# IBC 10-6

## BCAC exterior exit stairway protection

**Reason:** Clarify which rating of walls around exterior stairway.

Figure 1

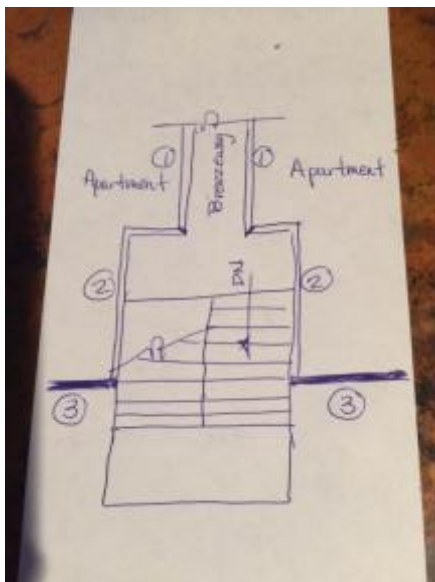
For Figure 1 -

Exception 3.2 - The corridor rating is  $\frac{1}{2}$  hour per Table 1020.1. So that is the wall labeled 1.

Exception 3.4 - The current reference (Section 1023.7) is to exterior walls of interior stairways. To protect the stairways for egress from a fire inside the room seems like it should be the section on construction (Section 1023.2). That is the walls labeled 2. That would require 1 hour for up to three stories, and 2 hours for four stories or more. This also would not allow openings other than doors to face the stairway. In addition to correcting the reference the proposal removes 'exterior'. While the walls are open to weather, there seems to be inconsistent interpretation on if walls on a covered breezeway are interior or exterior.

The last sentence of the main text references 1023.7 (That is the wall labeled 3).

Figure 2

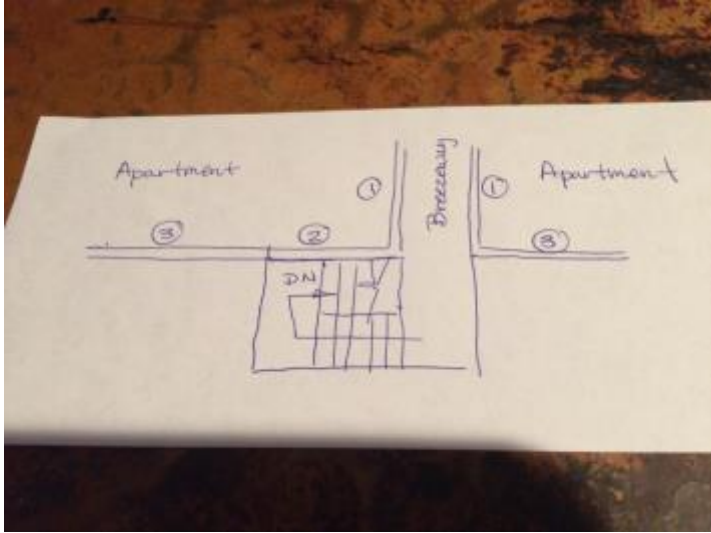
Does this still work for exterior stairways totally outside of a building as indicate in figure 2?
